Major Project Assessment

Department of Planning

RE: Application No: MP08_0195 78-90 OLD CANTERBURY ROAD, LEWISHAM CONCEPT PLAN

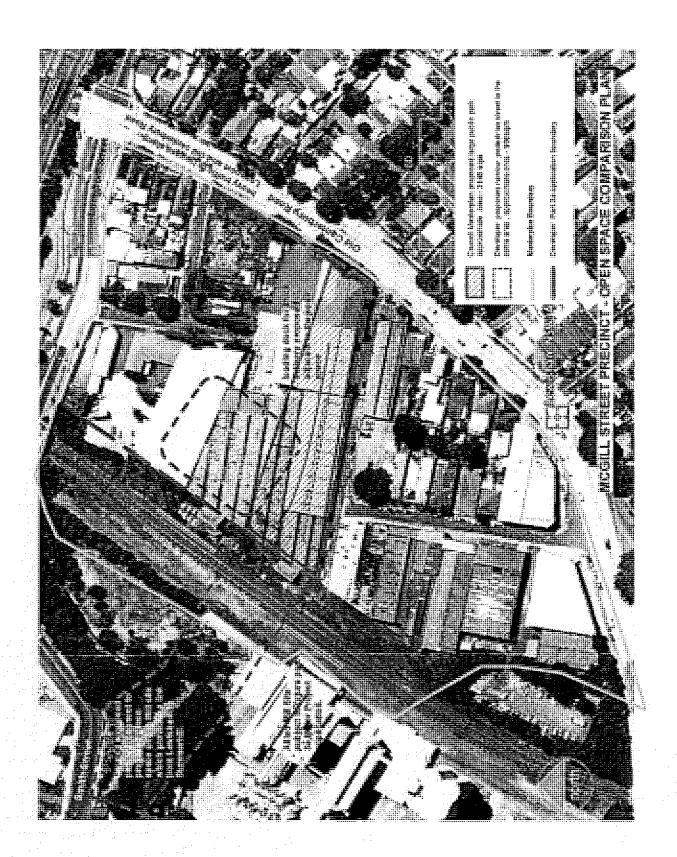
Bobs the tool costs entities of the cost use asystem was suggested uses only and are for Openical to consider on uppositing his that LEP.

The land uses synchold strated by the read in conjenting roll in Record to operated department (refer pages 44 and 15). Ney fand and nothers for the Belief Sheet prached realists the Kelbraney
